ALAMEDA COUNTY  
HEALTH CARE SERVICES

RE: Work Plan Approval for 1629 Webster Street, Alameda, CA

I have completed review of Environmental Resolutions, Inc.'s October 2002 *Work Plan for Remedial Excavation* prepared for the above referenced site. The proposal to excavate hydrocarbon-impacted soil in the vicinity of the former eastern dispenser island and monitoring well MW2 is acceptable. Field work should commence within 45 days of the date of this letter, or by **December 16, 2002** (when depth to groundwater is lowest). Please provide 72 hours advance notice of field activities.

FIGURE 1

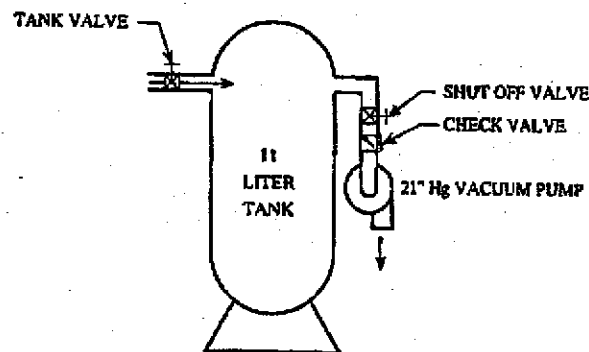
Attached is a figure explaining the purge technique that was used on 7/30/98 to collect vapor samples at the above referenced site. I previously stated, in the February 5, 1999, Soil Vapor Sample Collection Update, that we rejected the 7/30/98 data because the purge volume was unknown. I thought purge volume could not be estimated because the vacuum/volume system flow rate was not recorded.

At the request of my supervisor and Richard Weiss, I re-investigated the possibility of estimating the purge volume. I discussed the use of the purge equipment with the manufacturer (Geoprobe Systems). Based on my discussion with Geoprobe, I concluded that the maximum possible purge volume was 7.72 liters as described in the attached figure. We found this purge volume acceptable. Please call me at 510 450-6193 if you have any questions. Geoprobe Systems can be contacted at 1-800-436-7762 if you have questions about technical aspects of the Vacuum/Volume System A1-1001.

Based on our discussion with the manufacturer, Geoprobe Systems, the purge technique was consistent with their standard procedures for use of the Vacuum/Volume system. The Vac/Vol system evacuates 11 liter tank until 21" Hg gage pressure is achieved. The vacuum pump is shut off and the pump shut off valve is closed. The vapor sampling lines are then purged by opening the tank valve and drawing purge air in under the tank vacuum. The WA geologists allowed the tank to draw purge air in for 5 minutes. The maximum purge volume that can be removed by this system under 21" Hg is 7.72 liters. 7.72 liters will influence a subsurface spherical volume of approximately 14" diameter, which would be within the area of the trench backfill (see Figure 1 & 2). The sand backfill is approximately 100 times more permeable than the surrounding soil. Thus, we are confident that only trench vapors were sampled.
